4. Somerset Street - Midtown Project

**LEGAL ADVERTISEMENT
PORTLAND PLANNING BOARD MEETING**

- i. Midtown Project; Level III Subdivision and Site Plan, Conditional Use, Site Location of Development, and Traffic Movement Permit; Somerset Street; Federated Companies, Applicant. The Board will consider the final plan application for the "midtown" project, which is located in the B-7 zone. The 3.5 acres site is bounded by Somerset Street, Elm Street, the Bayside Trail and the extension of Pearl Street. The mixed-use proposal includes 445 residential units in four buildings with a maximum height of six stories. A seven story parking structure with 828 vehicle spaces is proposed as a conditional use. The total footprint of the buildings is 121,400 sf and the total floor area is 750,200 sf with 87,200 sf of retail space proposed. The workshop will focus on the following topics, but is not limited to: Architectural Design and the B-7 Design Standards and Waivers; Stormwater Management; Somerset Street Design; Traffic Movement Permit; Pedestrian Circulation; and Civil Engineering Waivers.

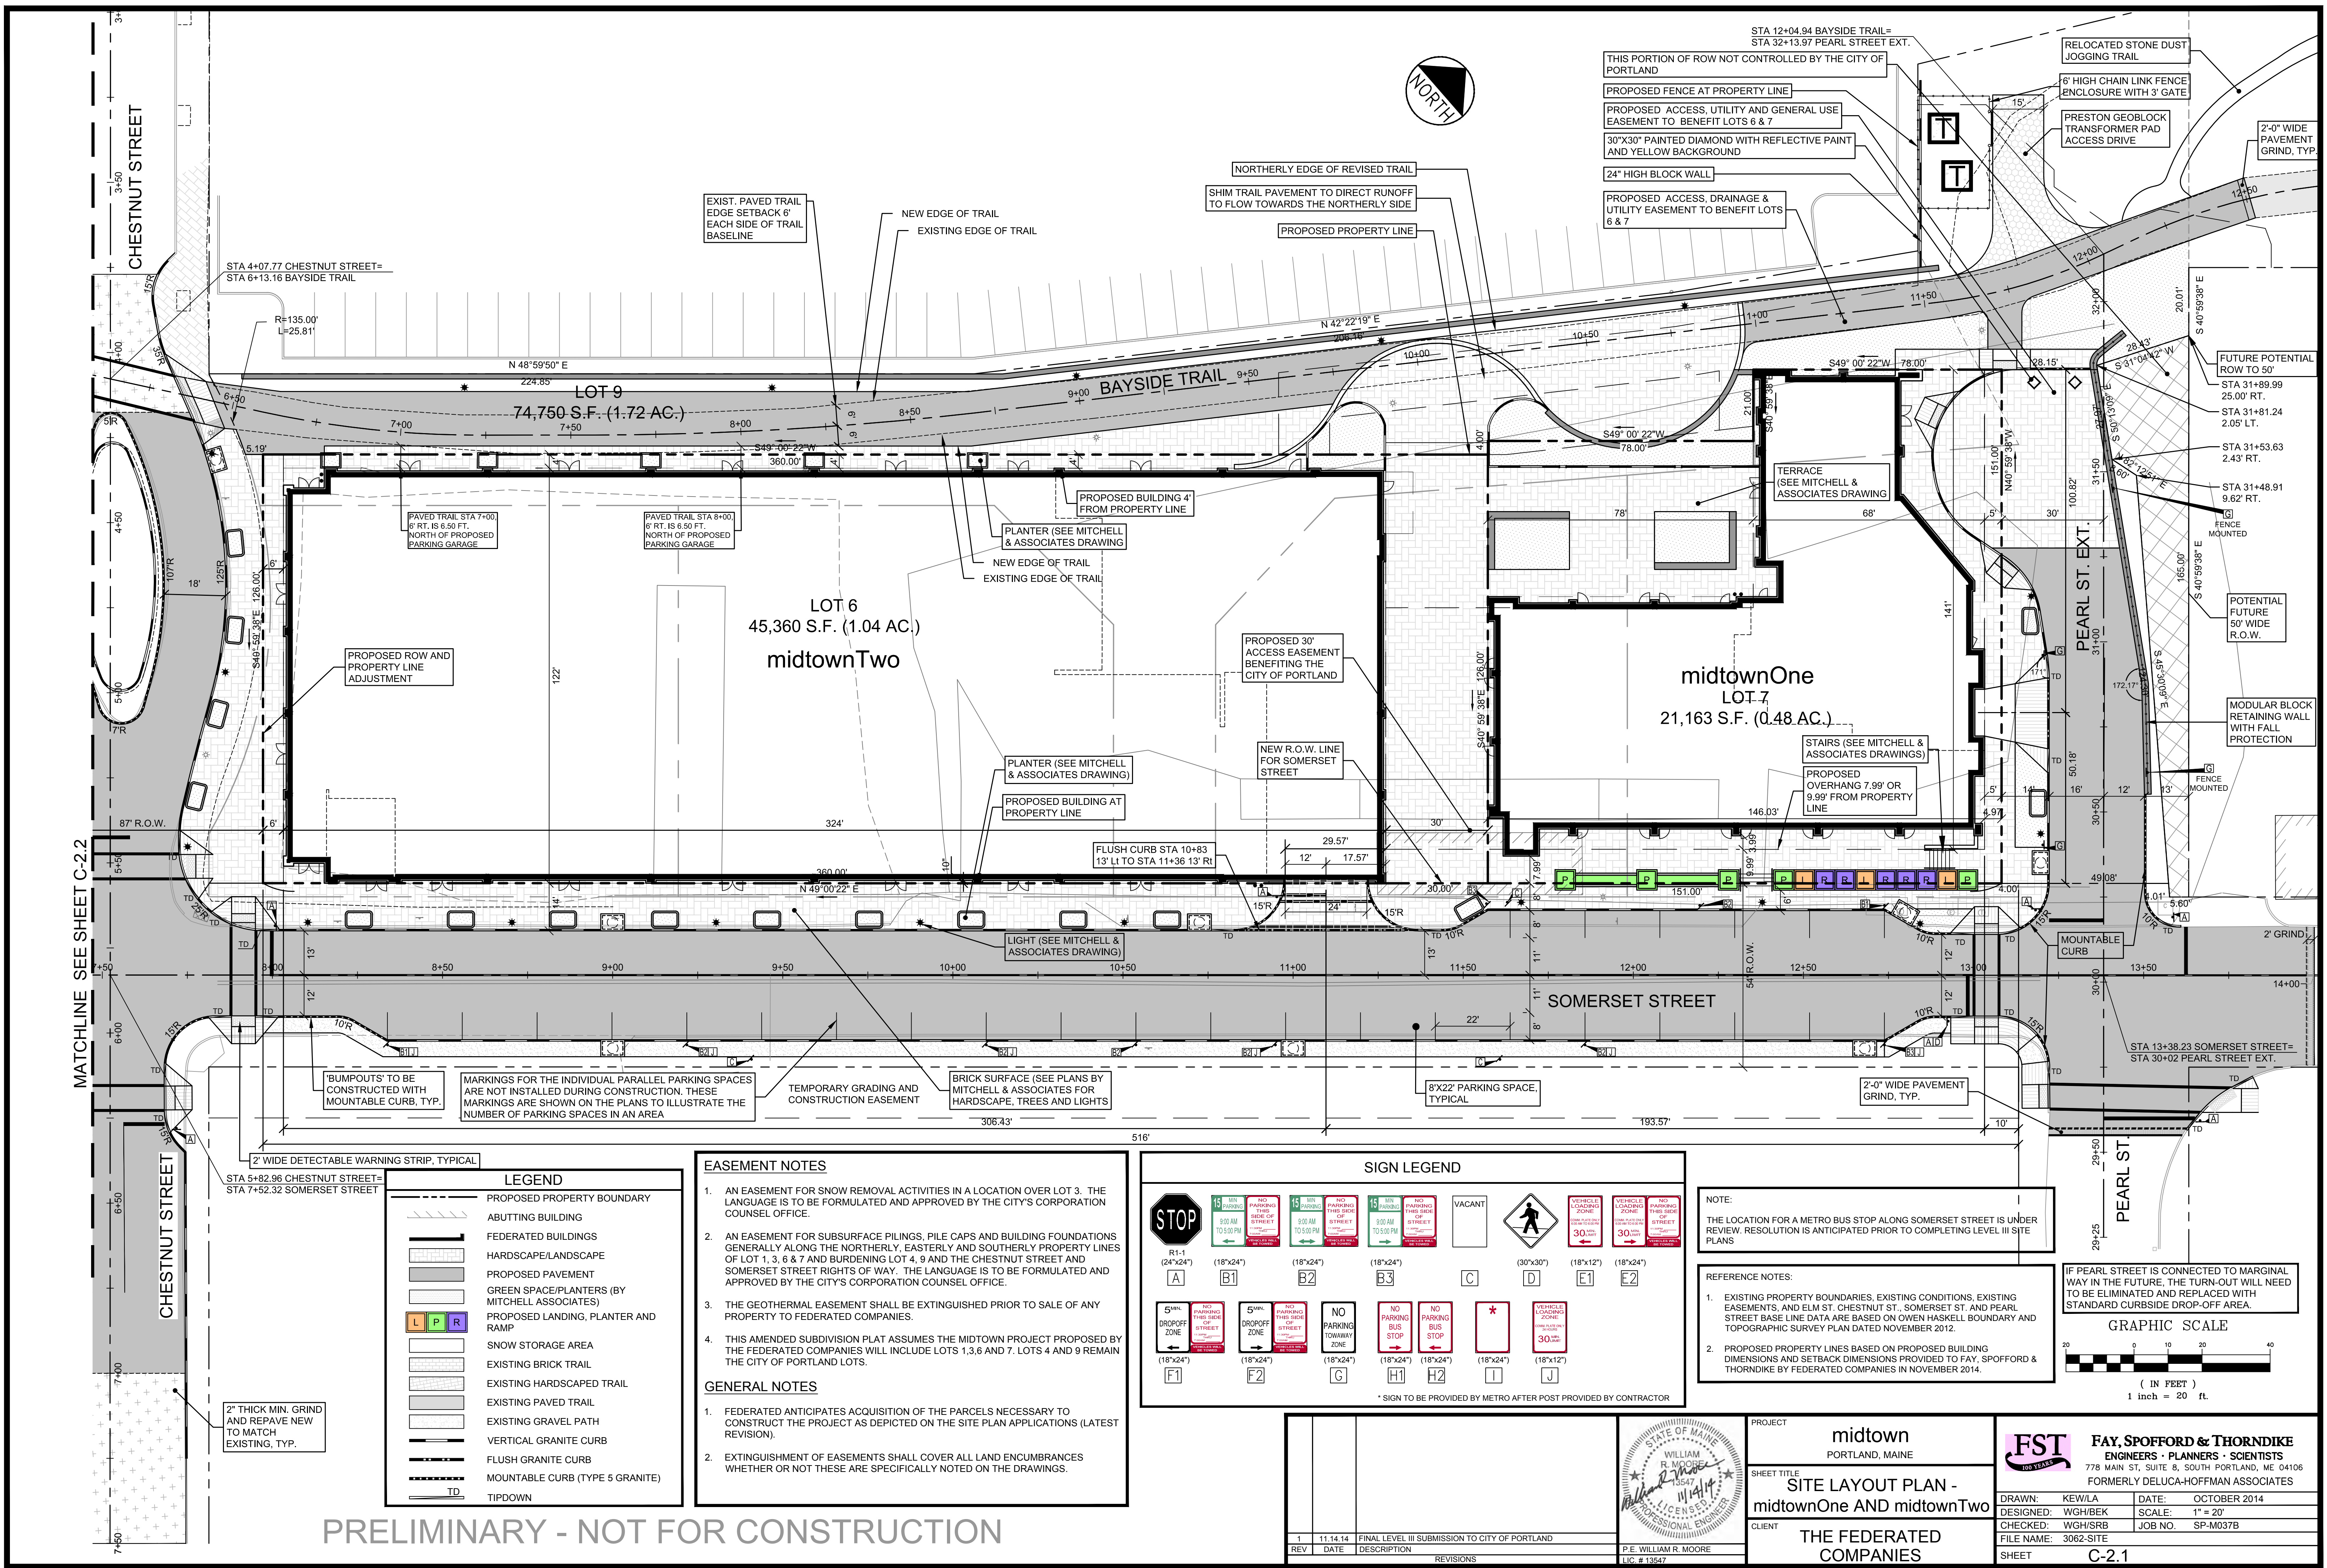
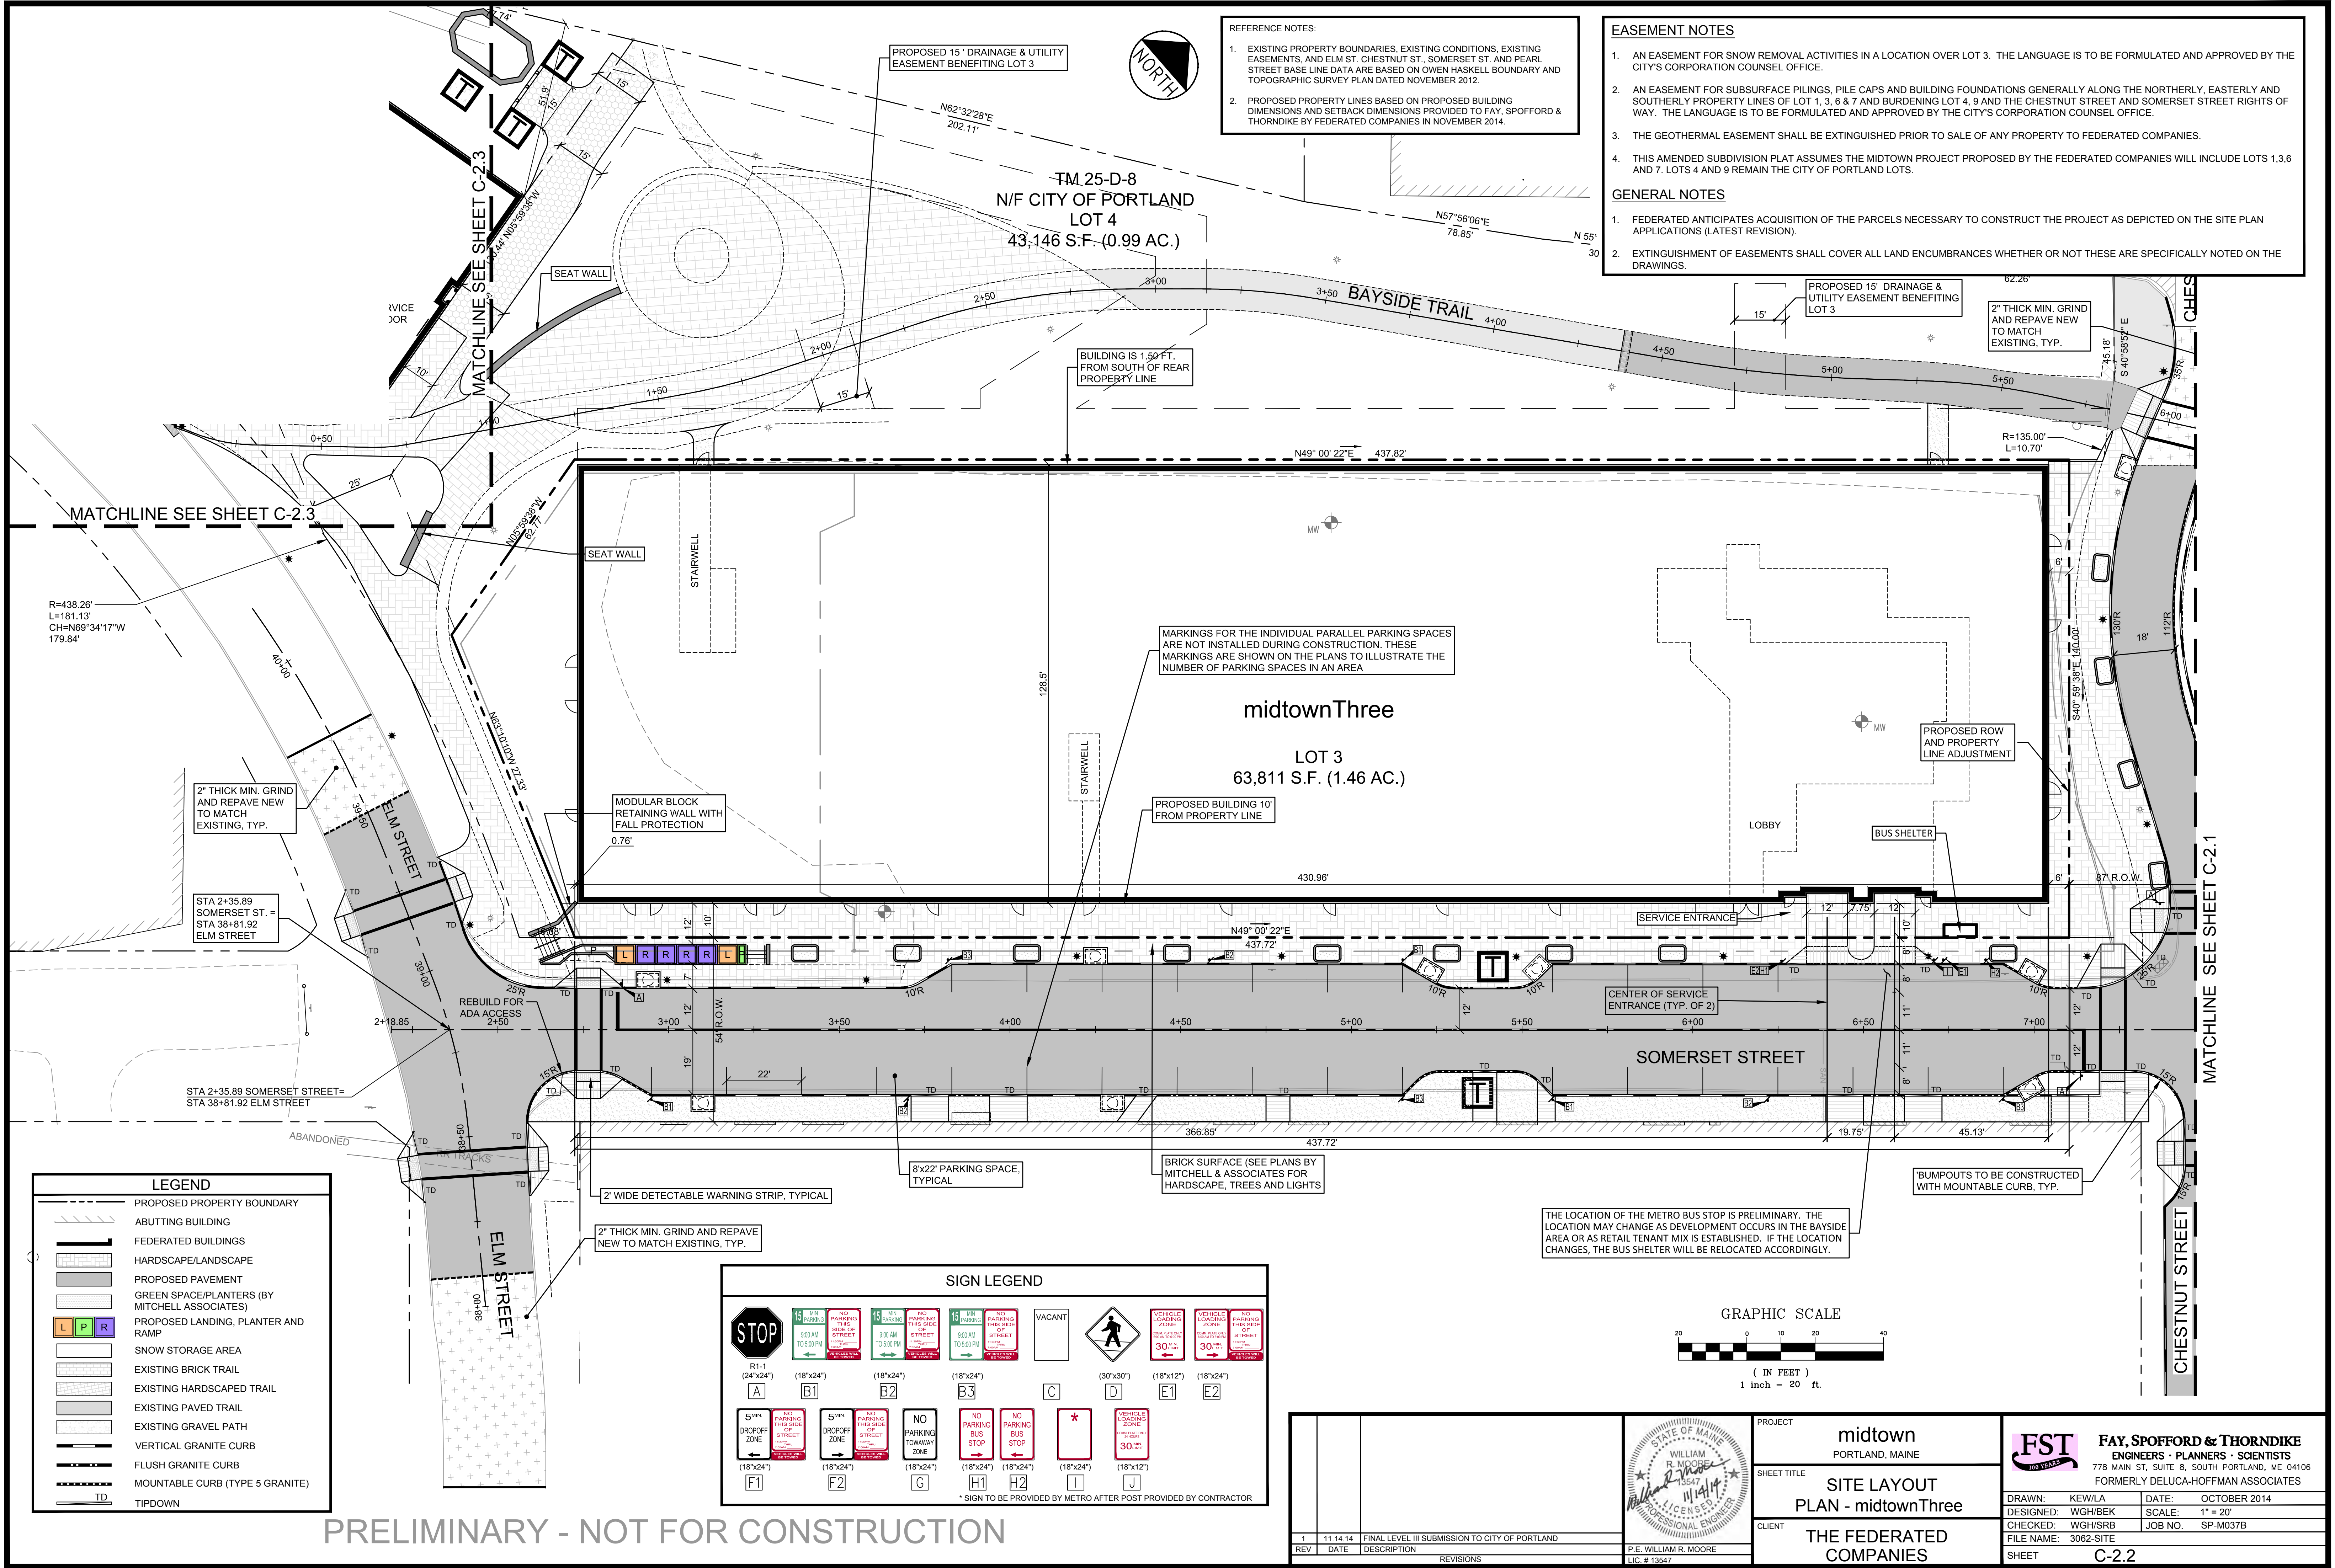
- The section of sidewalk along Elm Street between Midtown 3 and Midtown 4 does not provide a direct accessible pedestrian route (as depicted on Sheet C-2.0B). Pedestrians should not need to divert along the Bayside Trail for an ADA-compliant route on Elm Street.

- The proposed bus stop location does not (per drawing C-2.0B) provide the required ADA-compliant bus stop landing area (5'x8') nor does the bus stop directly connect to the ADA-compliant pedestrian access route at this location.

The section of sidewalk along the street between Midtown 3 and Midtown 4 does not appear to provide an accessible pedestrian route as shown on Sheet C-2.0B.

- The ramp and landing system on the NE corner of Elm Street-Somerset significantly interferes with pedestrians walking along Elm Street and is not ADA-compliant. The tree in front of this ramp and landing area hinders the pedestrian access route along the street and should be relocated or eliminated.
- The section of sidewalk along Elm Street between Midtown 3 and Midtown 4 does not provide a direct accessible pedestrian route (as depicted on Sheet C-2.0B). Pedestrians should not need to divert along the Bayside Trail for an ADA-compliant route on Elm Street.
- The configuration of several curb ramps are not ADA-compliant; they are not aligned perpendicular to the flush curb portion of the ramp.
- Portions of the accessible pedestrian route depicted on C-2.0B are not ADA-compliant due to reliance on crossing the flare of a curb ramp.

Review Comment: The proposed bus stop location does not (per drawing C-2.0B) provide the required ADA-compliant bus stop landing area (5'x8') nor does the bus stop directly connect to the ADA-compliant pedestrian access route at this location.
